Access Compliance Report

Public Rights-of-Way

(Pedestrian Signals)

Intersection ID: N/A	Main Street:	Cross Street: N/A	Location: N/A
ADA ID: 0902BD7A7196	Signal Type: One Push Button-APS	Overall Compliance: No	Severity Score: BTN 1: N/A BTN 2: N/A No BTN: N/A
Codes/Mitigation Info/Possible Solution		Field Measurements/Component Compliance

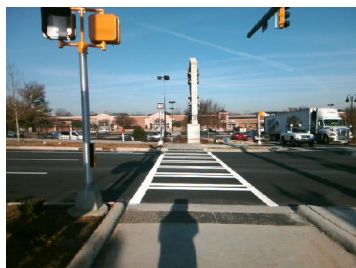
PROW/ADA: TMUTCD 4e.08, R404.2, R404.3, R404.7.3, R404.7.2,

N/A	B 1 FWD Approach Width (in)	N/A	N/A	B 2 FWD Approach Width (in)	N/A
N/A	B 1 FWD Approach Obstruction?	Yes	N/A	B 2 FWD Approach Obstruction?	N/A
N/A	B 1 FWD Approach Obstruction Dist (in)	4.0	N/A	B 2 FWD Approach ObstructionDist (in)	N/A
N/A	B 1 PARA Approach?	Yes	N/A	B 2 PARA Approach?	N/A
N/A	B 1 PARA Approach Constrained?	Yes	N/A	B 2 PARA Approach Constrained?	N/A
No	B 1 PARA Approach Reach (in)	14.0	N/A	B 2 PARA Approach Reach (in)	N/A
No	B 1 PARA Approach Width (in)	48.0	N/A	B 2 PARA Approach Width (in)	N/A
N/A	B 1 PARA Approach Obstruction?	Yes	N/A	B 2 PARA Approach Obstruction?	N/A
N/A	B 1 PARA Approach Obstruction Dist (in)	5.0	N/A	B 2 PARA Approach ObstructionDist (in)	N/A
No	B 1 Clear Floor Space Slope (%)	2.5	N/A	B 2 Clear Floor Space Slope (%)	N/A
Yes	B 1 Clear Floor Space XSlope (%)	1.3	N/A	B 2 Clear Floor Space XSlope (%)	N/A
N/A	B 1 PAR Slope (%)	N/A	N/A	B 2 PAR Slope (%)	N/A
Yes	B 1 Height (in)	37.0	N/A	B 2 Height (in)	N/A

N/A	B 1 Clear Xing Direction?	Yes	N/A	B 2 Clear Xing Direction?	N/A
	B 1 Crossing Direction	To NW		B 2 Crossing Direction	N/A
Yes	B 1 DistanceTo XWalk (in)	14.0	N/A	B 2 DistanceTo XWalk (in)	N/A
No	B 1 DistanceTo Curb (in)	10.0	N/A	B 2 DistanceTo Curb (in)	N/A
Yes	B 1 Diameter (in)	2.0	N/A	B 2 Diameter (in)	N/A

Possible Solutions: Replace Signal Push Button With APS Button on New Post. Remove & Relocate Sign.
